Nomad SERVICE BULLETIN

SUBJECT: REPOSITIONING OF OXYGEN REGULATORS.

S/B No. N22-35-1

FIGURE I LH INSTRUMENT PANELS ASSEMBLY REWORK

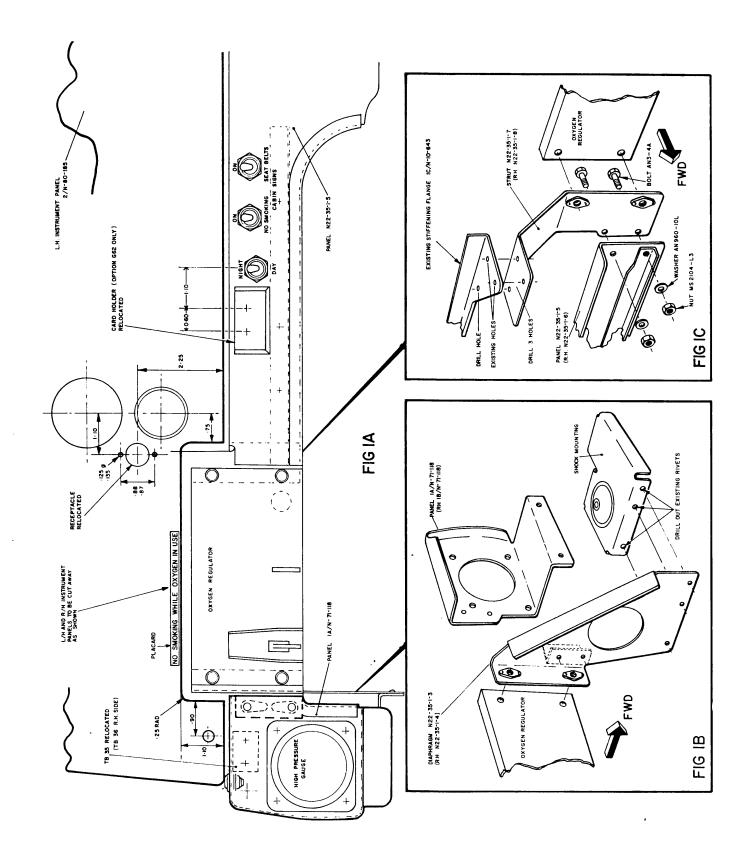
- (3) Position loose-assembled parts and, using the two rivet holes drilled out in step (2) as a guide, drill three No. 30 holes in the stifening flange 1C/N-10-643.
- (4) Remove panel N22-35-1-5 from the strut (to provide access) and attach the strut to the stiffening flange, using rivets MS20470AD4-5.
- (5) Attach the card holder (Ref. Fig. 1A) to the panel.
- (6) Install panel N22-35-1-5.

- G. Refer to Fig. 1A and install the high-pressure gauge, the oxygen regulator and the switches.
- H. Refer to Fig. 2 and install the low-pressure gauge, the oxygen regulator and the switch.
- I. Connect new wire L164A22 between terminal 1 of TB36 and the post light for the low-pressure oxygen gauge.
- J. Reconnect existing high-pressure pipe to the high-pressure gauge.
- K. Connect the following new low-pressure pipes:
 - (1) 1J/N-71-50, between the CREW OXYGEN shut-off valve and the L.H. oxygen regulator.
 - (2) 1K/N-71-50, between the L.H. and R.H. oxygen regulators.
 - (3) 1Z/N-71-45 and 1Y/N-71-50, between the CABIN OXYGEN shut-off valve and the low-pressure gauge. Use straight connector A400-6 to join the two pipes. Use elbow 400-2-2 to connect pipe 1Y/N-71-50 to the low-pressure gauge.

- CAUTION: IF MODIFYING AN INSTALLED PANEL, ENSURE THAT SERVICES BEHIND THE PANEL ARE NOT DAMAGED DURING REWORK.
 - D. Refer to Fig. 1A and rework the L.H. instrument panel 1/N-80-185 by cutting away the section indicated and relocating the receptacle as shown.

- E. Refer to Fig. 1B and assemble and install panel 1A/N-71-118 as follows:
- NOTE: Panel 1A/N-71-118 (L.H.) and panel 1B/N-71-118 (R.H.) are both mounted outboard of their associated oxygen regulator. Panel 1B/N-71-118 does not have provision for mounting an oxygen gauge.

- (1) Attach diaphragm N22-35-1-3 to panel 1A/N-71-118, using two bolts AN3-4A.
 - (2) Drill out the three rivets on the vertical flange of the shock mounting.

- (3) Attach panel 1A/N-71-118 to shock mounting, using existing screws MS27039-1-07.
 - (4) Rivet diaphragm N22-35-1-3 to shock mounting, using rivets AGS2050-424BS.

- (5) Relocate terminal block TB35 to position shown on Fig. 1A.
 - F. Refer to Fig. 1C and assemble and install panel N22-35-1-7, as follows:
 - (1) Loose-assemble panel N22-35-1-5 to strut N22-35-1-7, using attaching parts supplied.

FIGURE 2 RH INSTRUMENT PANELS ASSEMBLY REWORK

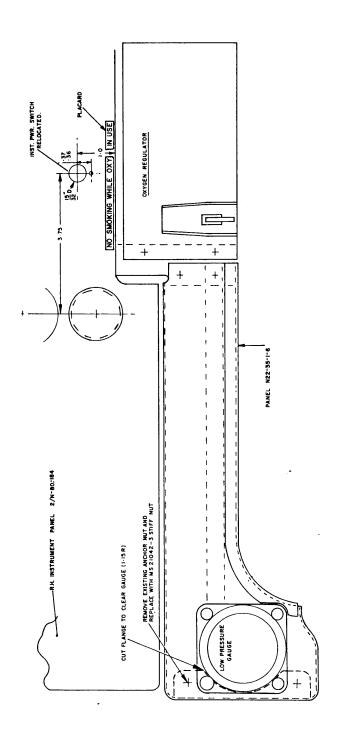
NOTE: Before installing the R.H. panel (N22-35-1-6), cut the mounting flange (Ref. Fig. 2) to provide clearance for the low-pressure gauge.
